The amendment revises Technical Specification Figure 3.1-1, Power Dependent Insertion Limits for Salem Generating Station, Unit No. 2.

SALEM NUCLEAR GENERATING STATION, UNIT NO. 2

Amendment No. 34  
License No. DPR-75

SAFETY EVALUATION BY THE OFFICE OF NUCLEAR REACTOR REGULATION  
RELATED TO AMENDMENT NO. 34 TO FACILITY OPERATING LICENSE NO. DPR-75

Figure 3.1-1  
ROD BANK INSERTION LIMITS VERSUS THERMAL POWER  
FOUR LOOP OPERATION

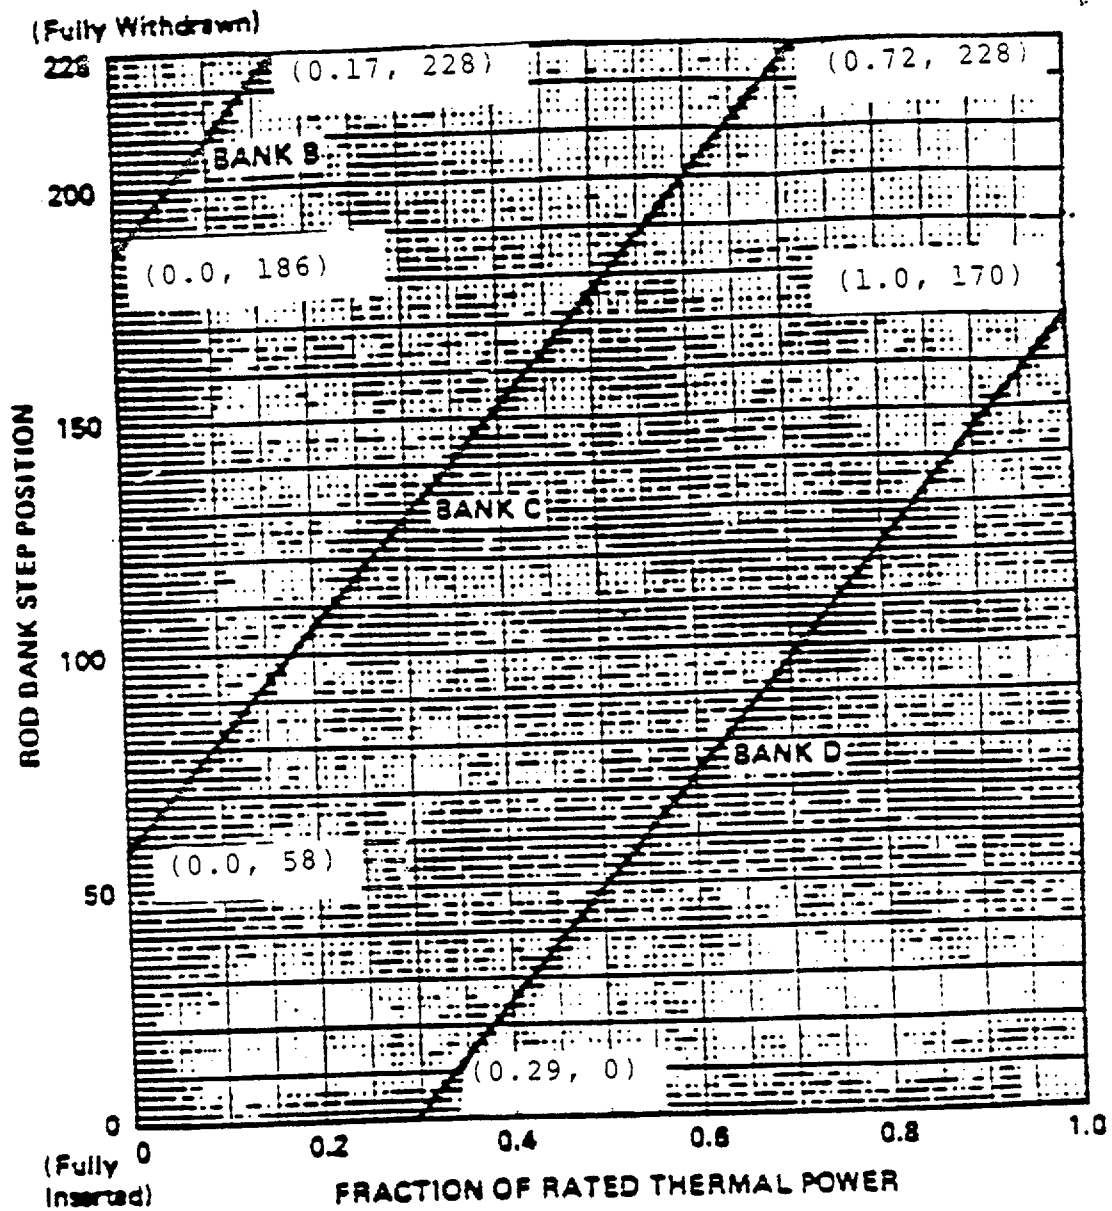
In a letter dated January 11, 1985, Public Service Electric and Gas Company (PSE&G) requested changes to the Power Dependent Insertion Limit (PDIL) of the Technical Specification (Figure 3.1-1) for Salem Unit 2. This change would match the Unit 2 PDIL curves with those of Unit 1.

This change is requested in order to gain operational flexibility which was lost due to reduction of rod insertion limits for Cycle 2 of Unit 2. The Cycle 3 reload design has been based on the proposed PDIL and a revised control rod pattern (bank grouping). The previous control rod pattern for Salem Units 1 and 2 differed considerably. The revised control rod pattern for Unit 2 would make the control rod patterns for Units 1 and 2 identical for control bank D, which is the most important control bank and almost identical for control bank C which is the next most important control bank. Bank B, the only other bank allowed in the core during power operation, must be fully withdrawn prior to 20% full power. The revision to the control rod patterns which was implemented during the Cycle 2-3 refueling outage was made under the provision of 10CFR50.59.

exceeded. Furthermore it was shown that the current core safety limits are still applicable and that the change in no way creates the possibility of a new or different accident from any accident previously evaluated for Salem. Based on our review of the submitted information and the Westinghouse RSE, we find the proposed Technical Specification change to the Power Dependent Insertion Limits to be acceptable.
